To:	Valmichael Leos and Anne Foster, USEPA	Date:	February 21, 2014
From:	Wendell Mears, Randy Brown, David Keith, John Verduin, and John Laplante	Project:	090557-01.04
Cc:	Dave Moreira and Andrew Shafer, MIMC Phil Slowiak, IP		
Re:	San Jacinto River Waste Pits TCRA Armored Cap Enhancement Completion Report

Figure 1
Armored Cap Enhancement Locations
TCRA Enhancement
San Jacinto River Waste Pits Superfund Site

Re: Armored Cap Enhancement Work Plan
San Jacinto River Waste Pits Superfund Site Time Critical Removal Action United
States Environmental Protection Agency, Region 6, CERCLA Docket No. 06-12-10

Re: San Jacinto River Waste Pits Superfund Site Time Critical Removal Action
Response to USEPA Questions on TCRA Cap Assessment
CERCLA Docket No. 06-12-10

Figure 1
Gradation of Armor Rock B/C
San Jacinto River Waste Pits Time Critical Removal Action

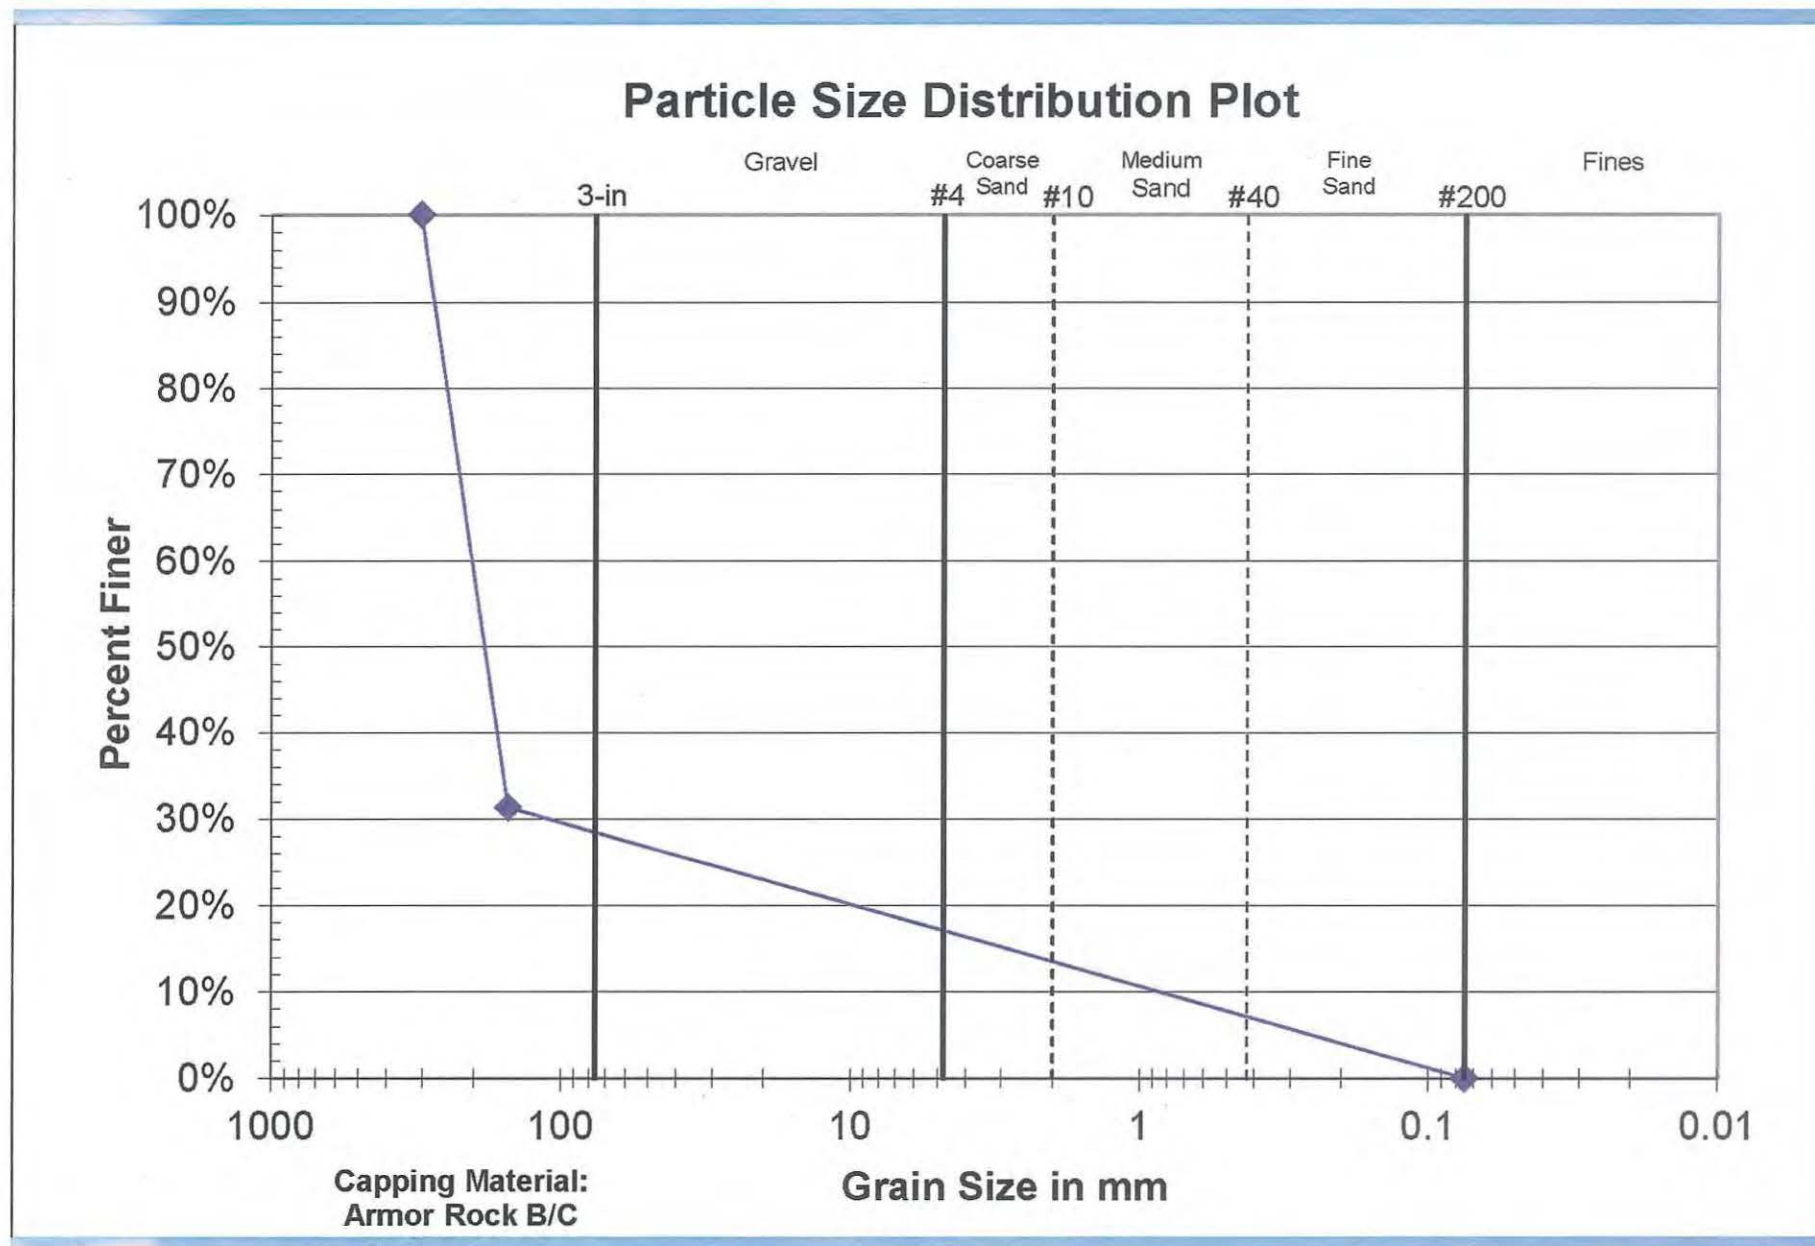
2. What is the measured or estimated grain size distribution for the B/C armor material?
Specifically, what are the

- a. D_{100}
- b. D_{85}
- c. D_{60}
- d. D_{50}
- e. D_{15}
- f. D_{10}
- g. D_{30}

Using the contractor gradation submittal for the B/C armor material, the following is the measured and estimated grain size distribution for this material:

- D_{100} 12 inches
- D_{85} 9 inches
- D_{60} 8 inches
- D_{50} 6 inches
- D_{30} 4 inches
- D_{15} 0.12 inches
- D_{10} 0.033 inches

A grain size distribution curve for this material is attached for reference.
